# Latency Estimation in Bridge Device For .1CM project

# Latency Estimation in Bridge Device

Figure C-3—Fronthaul example

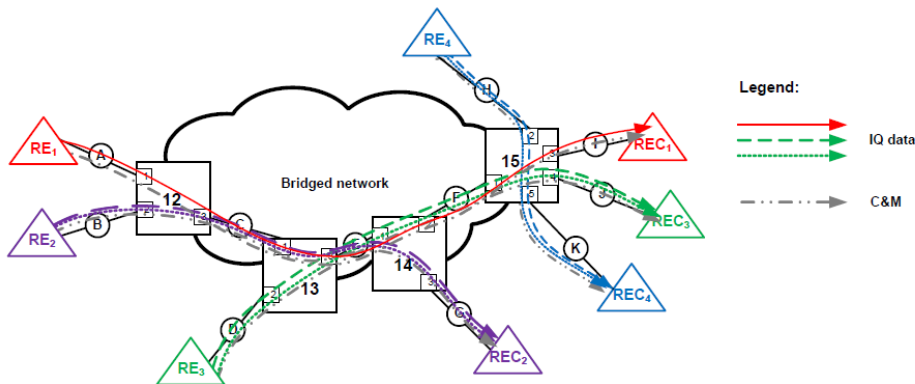
Bridge \ Flows	F <sub>p</sub>	F <sub>n</sub>	Min{F <sub>p</sub> , F <sub>n</sub> }
12	1	2	1
13	3	2	2
14	5	0	0
15	3	0	0

\*RED flow, from RE<sub>1</sub> to REC<sub>1</sub> is in observation

■ According to equation in section 7.3.1.3, revised value should be ,

\* $t_{queueing}$  reduces to 114.4ns with pre-emption from Profile A, for worst case 123-octets packet + Pre/SFD/IFG

## ■ Suggest to modify C.2.1

– Change text on line 3 on page 31:

- From “*In case of Bridge 12,  $t_{SelfQueuing}^{12} = 2 \times t_{1542} = 2.4672 \mu s$* ” to “*In case of Bridge 12,  $t_{SelfQueuing}^{12} = 1 \times t_{1542} = 1.2336 \mu s$* ”

– Change Table C-1 to

Bridge 12	Bridge 13	Bridge 14	Bridge 15	Total
$t_{MAXBridge}$	8.7008us	9.9344us	7.4672us	7.4672us	33.5696us

## ■ Suggest to modify C.2.2

– Change Table C-2 to

Bridge 12	Bridge 13	Bridge 14	Bridge 15	Total
$t_{MAXBridge}$	7.47864us	8.71224us	6.24504us	6.24504us	28.68096us
